TOTAL PERFORMANCE VAN'S AIRCRAFT

SERVICE BULLETIN 16-03-28

Affected Models: All RV-3, 4, 6/6A, 7/7A, 8/8A, 9/9A, 10, and 14/14A aircraft.

Subject: Cracking of wing aft spar web at the inboard aileron hinge bracket attach rivets. In addition, for RV-10 and RV-14/14A aircraft, there is a potential for cracking of the flange bends of the inboard aileron hinge brackets.

FIGURE 2: INSPECT AILERON HINGE BRACKET

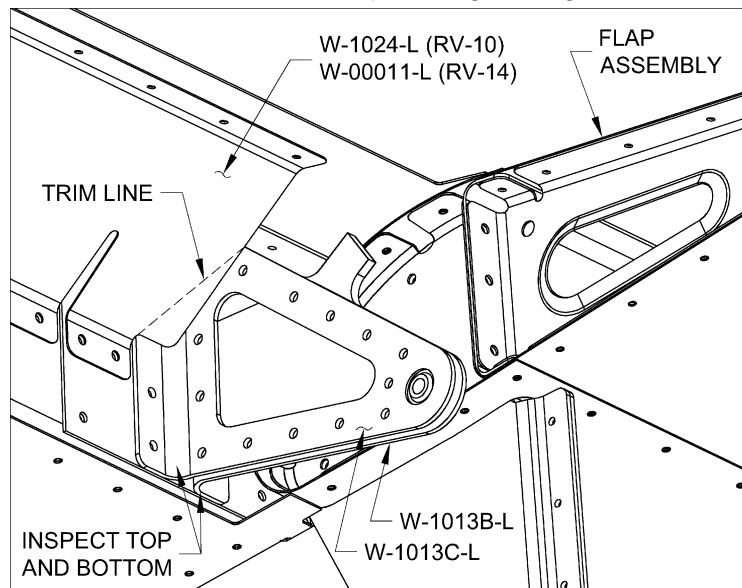
Step 2 (RV-10 & 14 only): To gain access for inspecting the top of the W-1013C Aileron Hinge Bracket Sides, remove the ailerons from the wings as instructed in Step 3 and 4, then trim off the corner from the W-1024 / W-00011 Aileron Gap Fairings along the "TRIM LINE" shown in Figure 2.

Inspect for cracks in the flange bends at the top and bottom of the W-1013C & B Aileron Hinge Bracket Sides.

- If cracks are detected, continue with the remaining steps in this service bulletin before further flight.
- If cracks are not detected, reattach the ailerons and make a log entry indicating that recurrent inspection is due at the next condition inspection.

FIGURE 3: TRIMMING THE AILERON GAP FAIRING

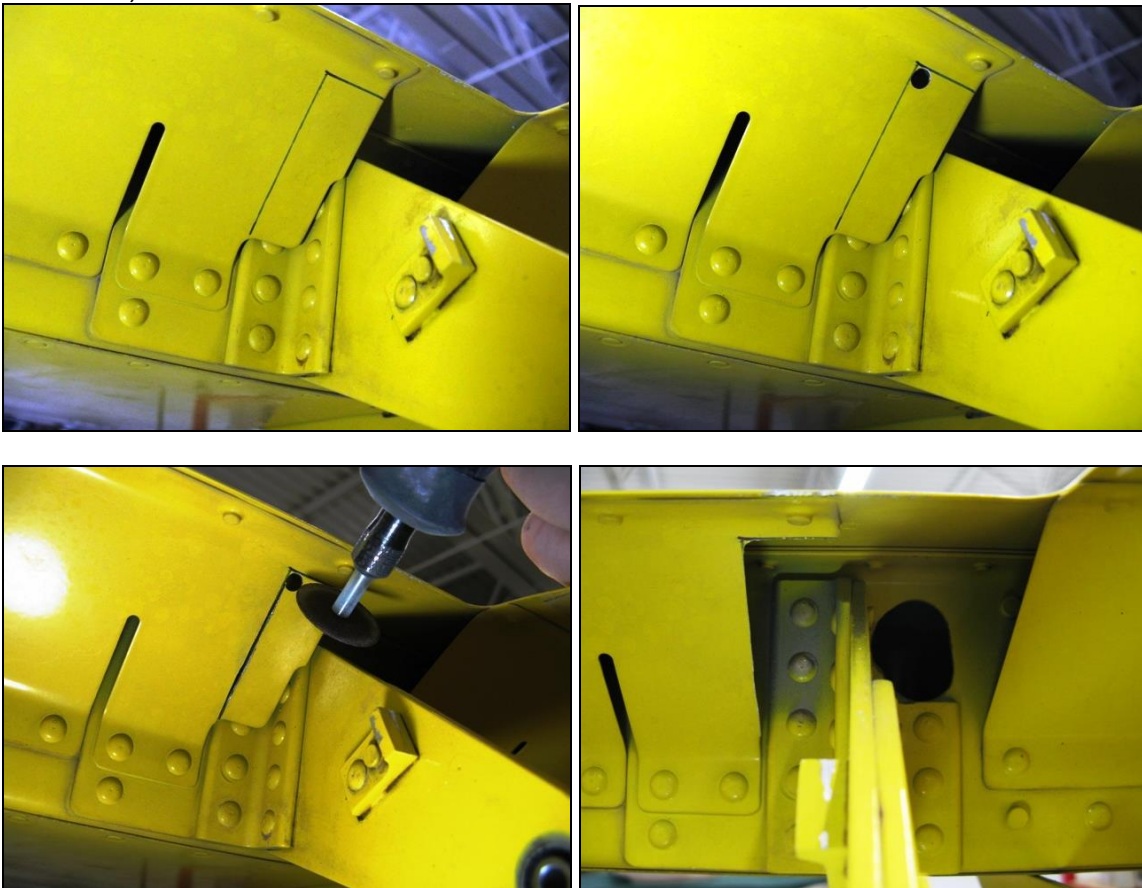
Step 7: Remove a portion of the aileron gap fairing if it interferes with access to the rivets attaching the aileron hinge bracket to the rear spar as shown in Figure 3. Drill a 3/16 corner hole and then use a cutting disk in a die grinder or Dremel™ type tool to remove a small section of the gap fairing. (RV-10 & 14 only: When upgrading to the W-1013D, W-1013E, and W-1013FG Aileron Hinge Bracket parts, it will be necessary to remove the two bottom rivets in the tabbed portion of the aileron gap fairing. This will allow for slight trimming of the fairing adjacent to the tab to clear the wider aileron hinge bracket. Maintain a .188 in. [4.8mm] minimum edge distance between the trimmed edge and tab rivet hole.)

FIGURE 10: SEPARATE THE AILERON ATTACH DOUBLER
(RV-3 & 4 DOUBLERS HAVE NO HOLES)

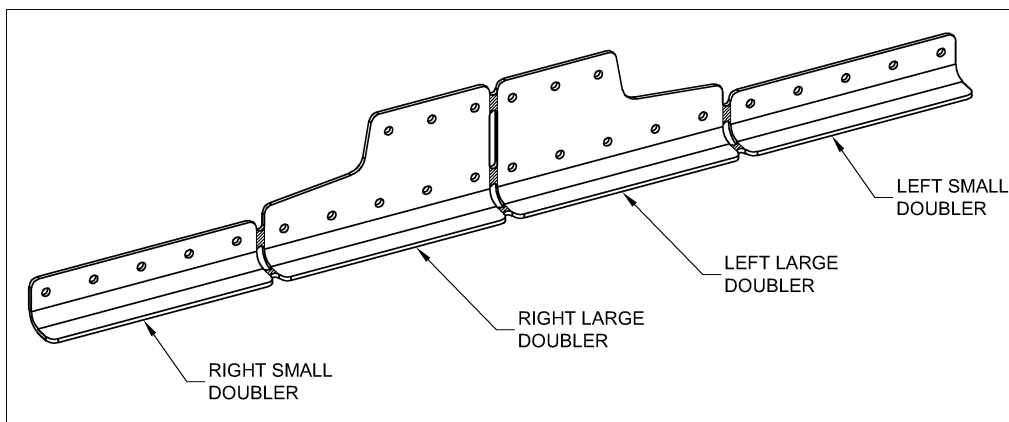
Step 15: Label, then separate the Aileron Attach Doubler into individual parts by removing the shaded areas shown in Figure 10.

FIGURE 11: MATCH-DRILLING THE AILERON ATTACH DOUBLER

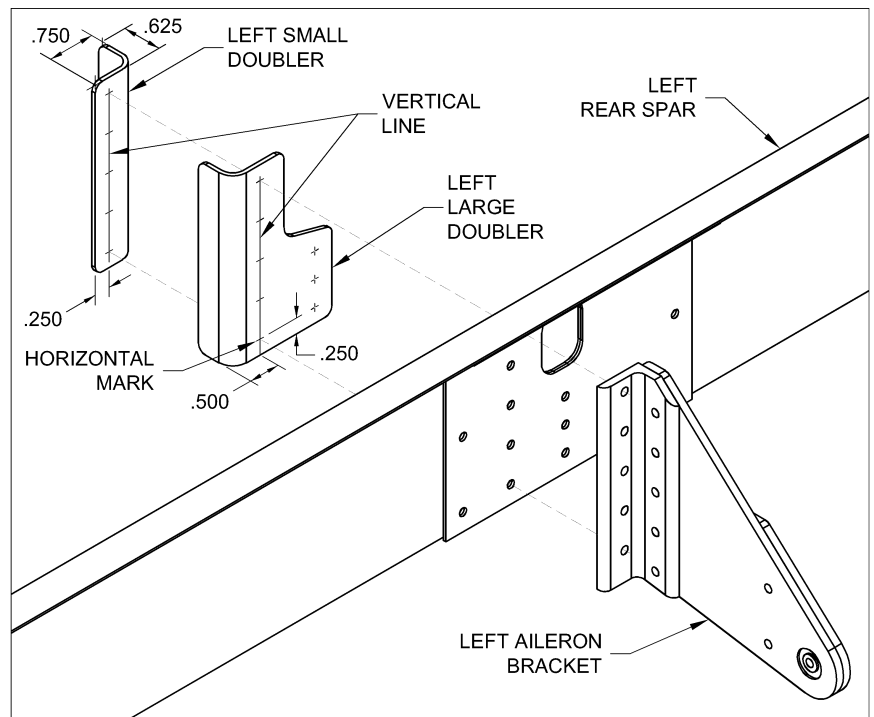
Step 16 (RV-3 & 4 only): The small doubler has a .750 in. [19.1mm] flange and a .625 in. [15.9] flange; draw a vertical line on the .750 in. [19.1mm] flange .250 in. [6.4mm] from the edge as shown in Figure 11.

Step 19 (RV-3 & 4 only): Place the small doubler on the forward side of the large doubler, as shown in Figure 11, and flush the top and bottom edges. Center the vertical line on the small doubler in the holes of the large doubler, clamp the parts together, then match-drill #30 the holes of the large doubler into the small doubler. Deburr the holes of both doublers.

FIGURE 12: SEPARATING THE W-1013FG AILERON ANGLE BRACKET

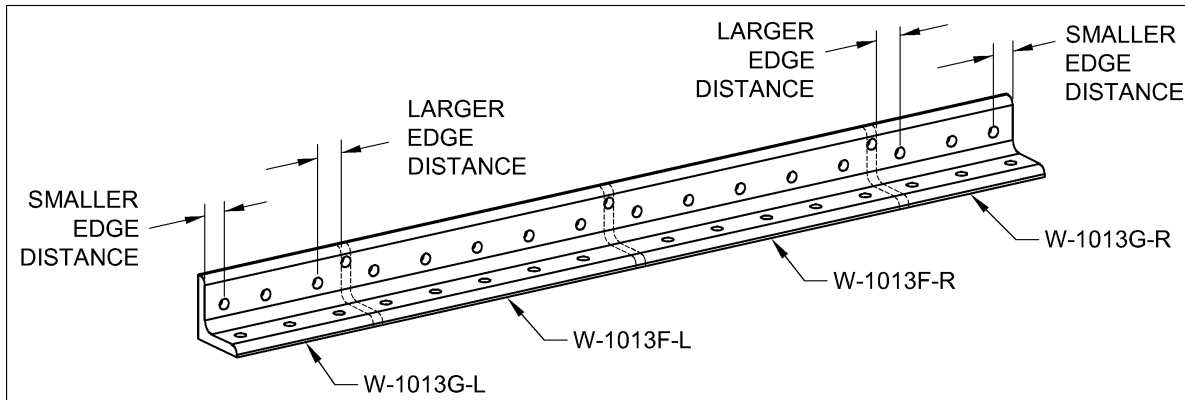
Step 20 (RV-10 & 14 only): First label (see note below), then separate the W-1013FG Aileron Angle Bracket into individual parts as shown in Figure 12. Separate the part at the three holes that are offset to the edge of one of the flanges. Cut perpendicular to the part, and trim away material the width of the hole across the entire part (file/sand if necessary).

NOTE: As shown in the figure, there is a slightly larger edge distance for the hole at one end of the W-1013G-L & -R Angle Brackets than at the other end. When orienting the parts in later steps, the hole with the larger edge distance is placed on the bottom, and the flange with this hole attaches to the spar web.

FIGURE 13: AILERON HINGE BRACKETS

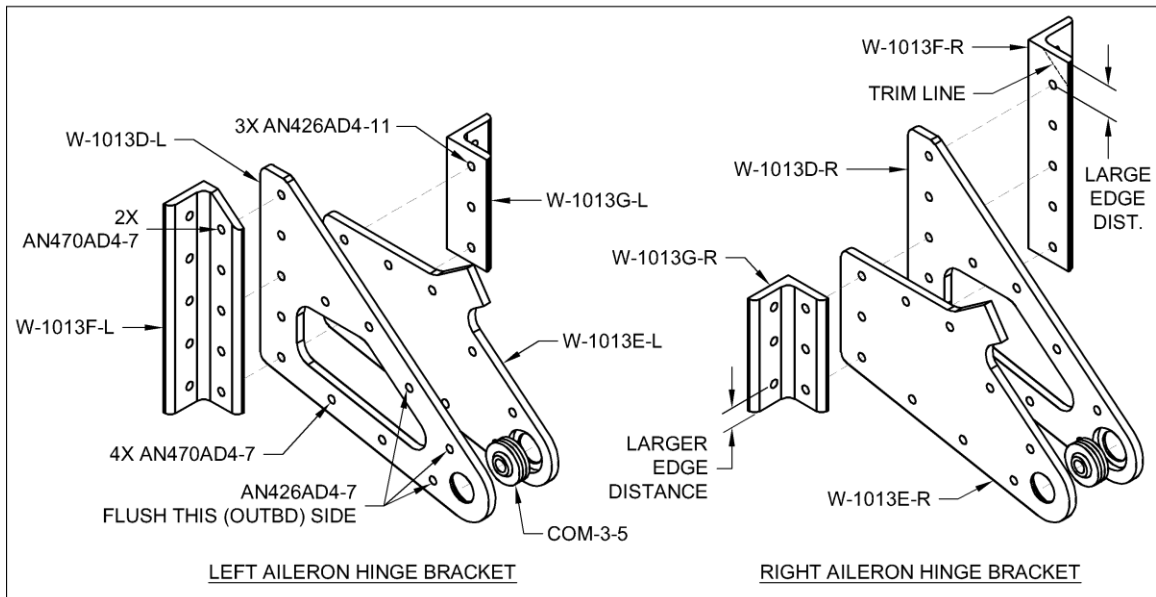
Date Released: May 6, 2016 (Initial release)
March 7, 2018 (Replaced AN470AD4-11 with AN426AD4-11 in Figure 13, added corresponding machine countersinking instructions to Step 24.)

Step 21 (RV-10 &14 only): If necessary, straighten the W-1013D & E Aileron Hinge Side Brackets (see Figure 13) as much as possible by clamping the parts in a bench vise and applying firm hand pressure. Sight along the edges to verify straightness and re-adjust as required.

Step 23 (RV-10 &14 only): Cleco together all of the parts shown in Figure 13 for the Left and Right Aileron Hinge Brackets (with the COM-3-5 bearings in place). Be sure to orient the W-1013F Aileron Angle Brackets to place the hole with the larger edge distance at the top, and, as previously noted, orient the W-1013G Aileron Angle Brackets to place the hole with the larger edge distance on the bottom.

Step 24 (RV-10 &14 only): Draw a line on the flange of the W-1013F Angle Brackets that matches the sloped edge of the W-1013D Side Brackets. Disassemble the parts, trim the flange along the line, then deburr the edge.

As called out, machine countersink the three holes in the W-1013D-L & -R Side Brackets flush on the outboard side. Machine countersink the three lower holes in the W-1013F-L & -R for the flush rivets common to the W-1013G-L & -R. Deburr the drilled holes in all parts.

Step 25 (RV-10 &14 only): Prime all parts, then cleco the Left and Right Aileron Hinge Brackets back together and rivet them as called out in Figure 13. Set the rivets in a random pattern to inhibit warping.

FIGURE 14: AILERON HINGE BRACKET RIVETS

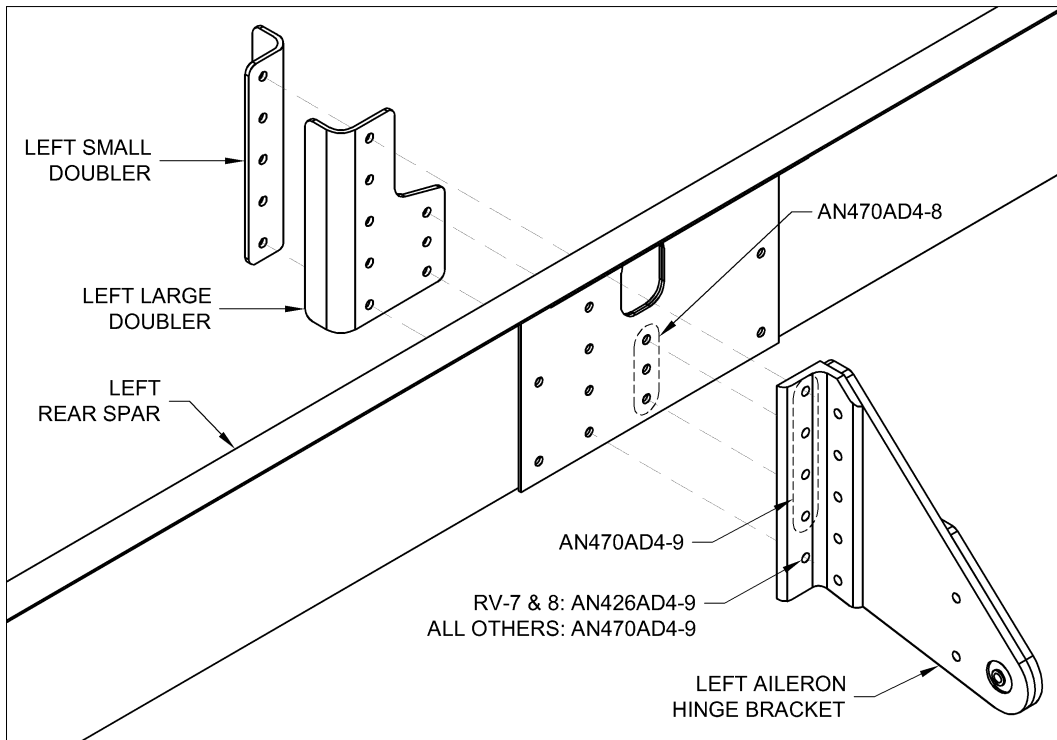
Step 26: Cleco, then rivet the small and large doublers and the Aileron Hinge Brackets to the rear spars using the rivets called out in Figure 14. Final-Drill #30 any hole into which a rivet cannot be inserted. Note that for the RV-7 & 8, the bottom hole in the outboard angle bracket uses a flush rivet.
